*Amndt -22
to DPR-49*

DUANE ARNOLD ENERGY CENTER

AMENDMENT TO FACILITY OPERATING LICENSE

Amendment No. 22
License No. DPR-49

FIGURE 4.3-1 RADIOLOGICAL ENVIRONMENTAL MONITORING PROGRAM SAMPLING STATION

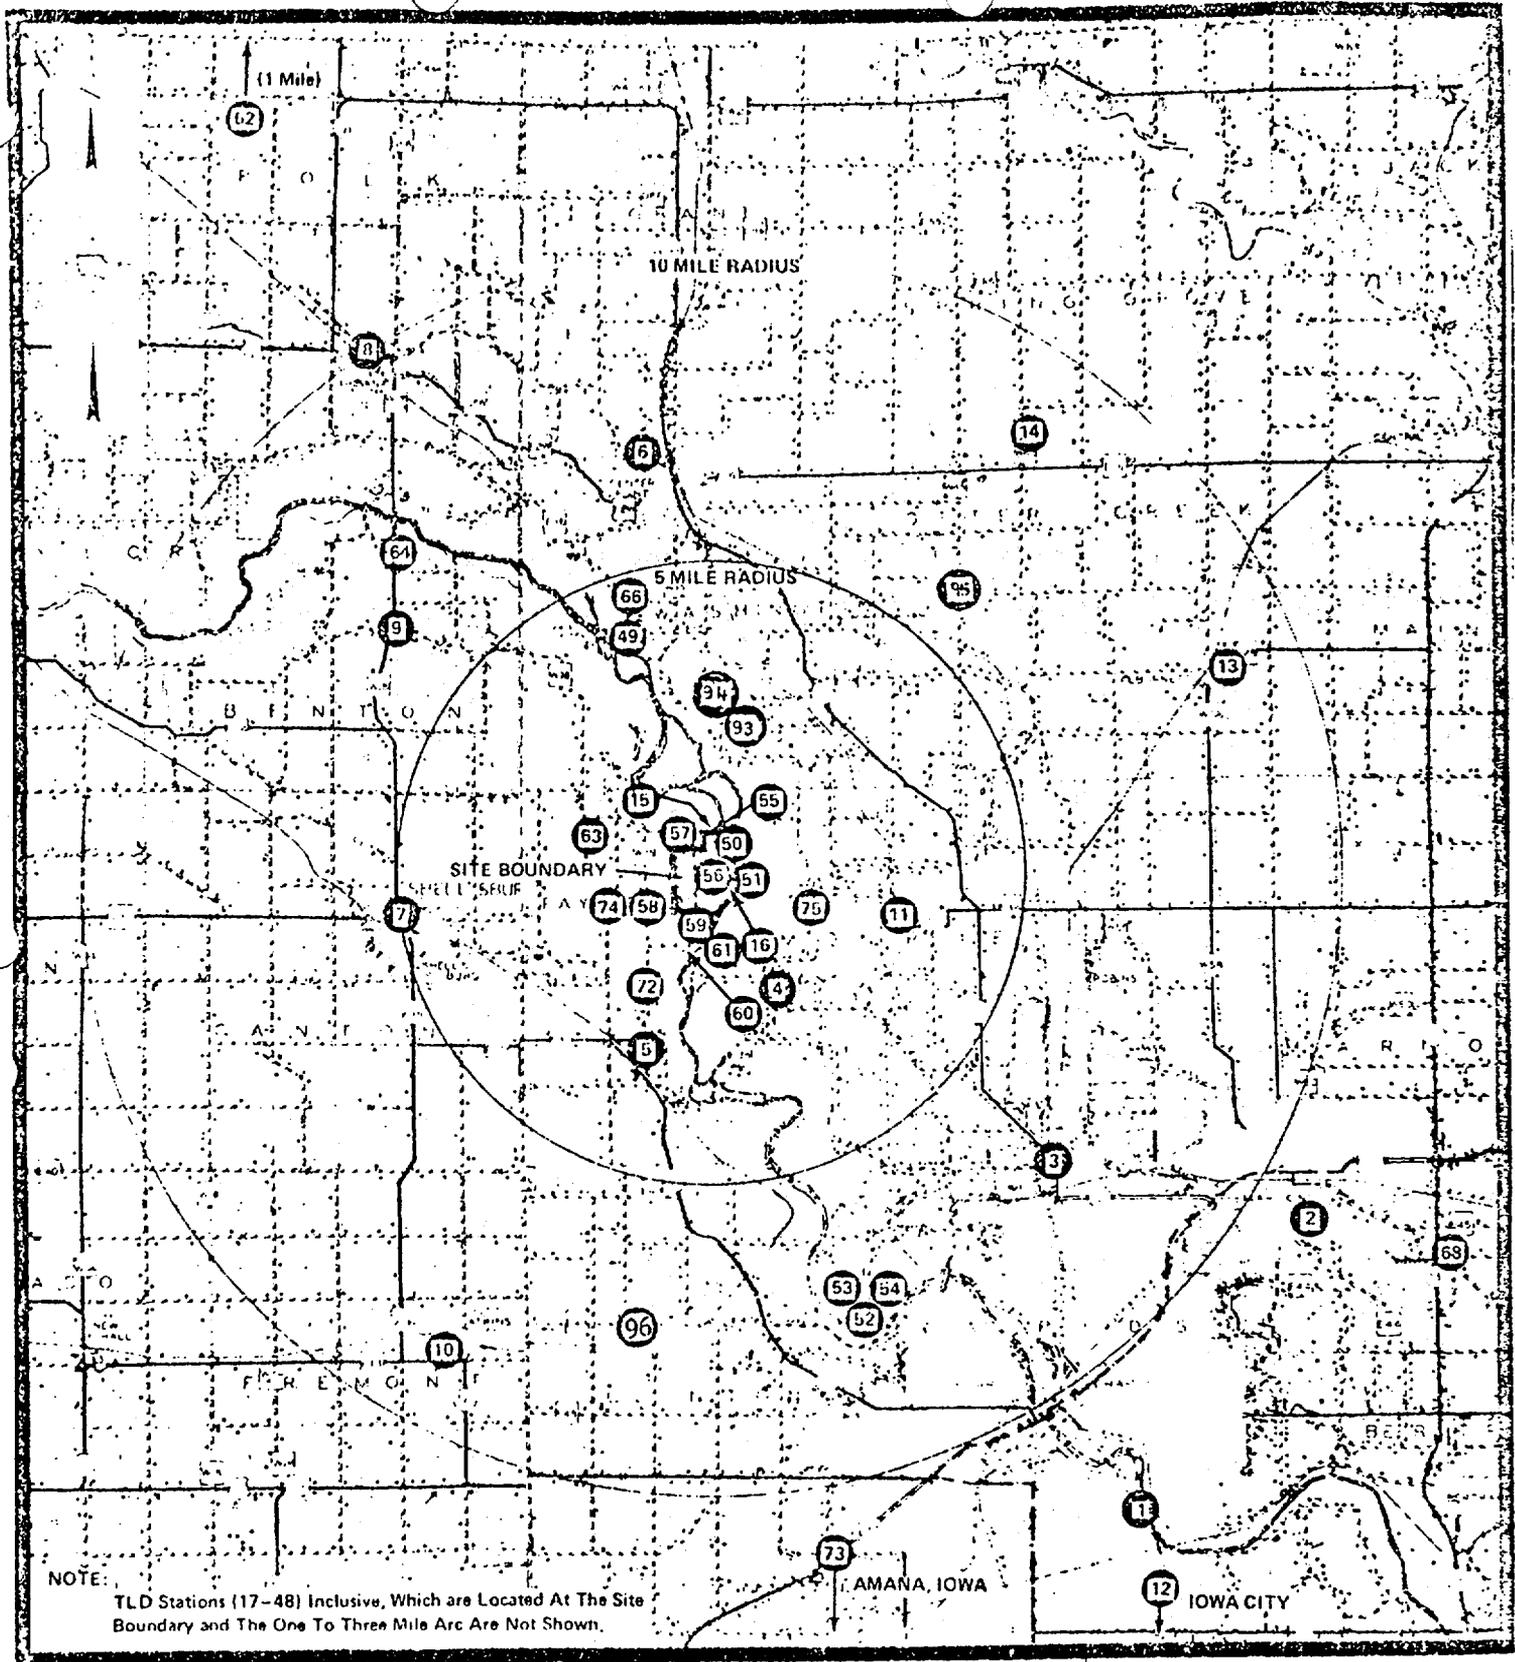
The amendment also involves the discontinuation or change in location of certain sample stations and addition of new sample stations, where appropriate, to reflect the change in availability of certain sample types at given locations, and changes in frequency of sampling where such changes are appropriate because of the unavailability of samples under changing seasonal conditions or because data already accumulated have shown the nonproductivity of continued sampling at frequencies required in the past. We have determined that such allowed modifications in sampling stations and sampling frequency are appropriate and do not lessen the effectiveness of the sampling and monitoring programs.

- A. Environmental samples shall be collected and analyzed according to Table 4.3-1 at the locations shown in Figure 4.3-1.
- B. Reports shall be submitted in accordance with the requirements of Section 5.4 (Plant Reporting Requirements).
